19 November 2019

**RE: Peer Review of Visual Impact Review prepared by MHBC Planning Limited
Capital Paving Inc. Shantz Station Pit
Our File: 19554**

Figure 2 View of 1224 Maryhill Road from frontage of St. Boniface Church

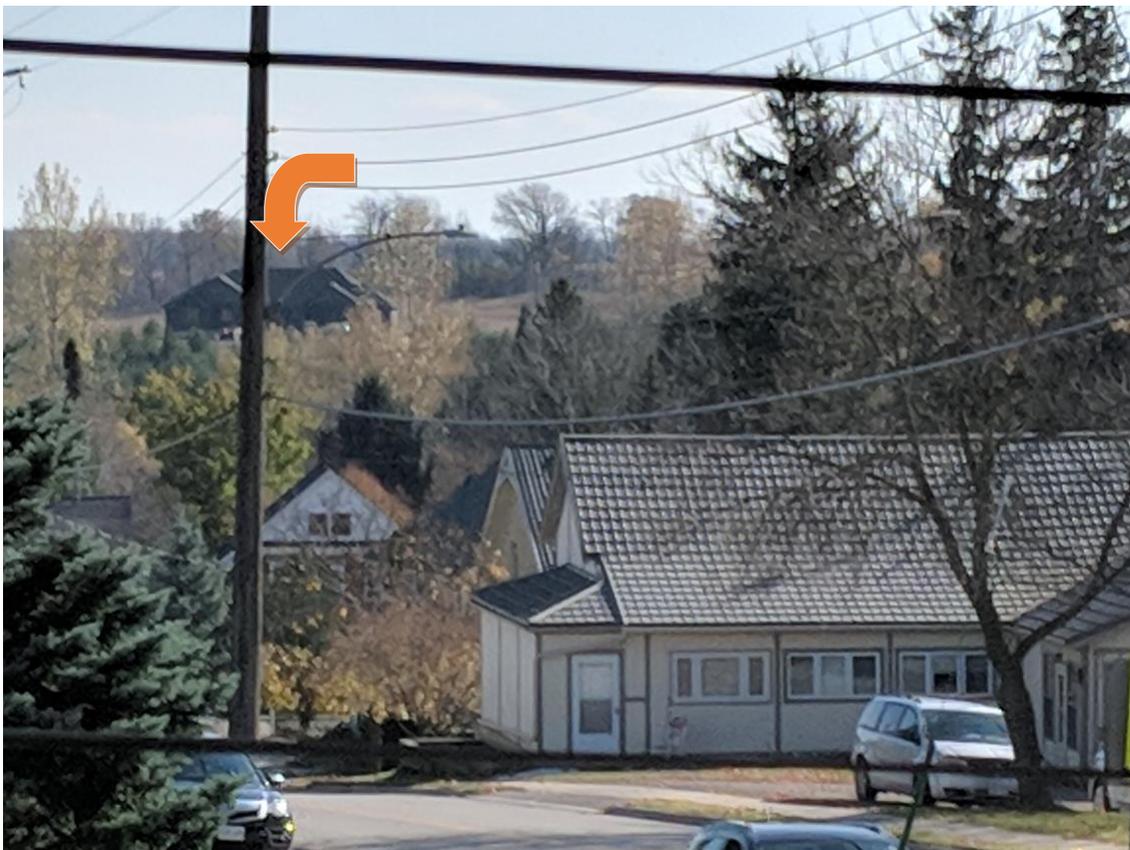
Figure 2 below demonstrates the view of the residence at 1224 Maryhill Road from St. Boniface Church taken during the WND Associates site visit.

the residences identified within the submitted VIR. An addendum or update to the VIR should be provided to evaluate the potential for visual impact to 1224 Maryhill Road and whether further mitigation measures are required.
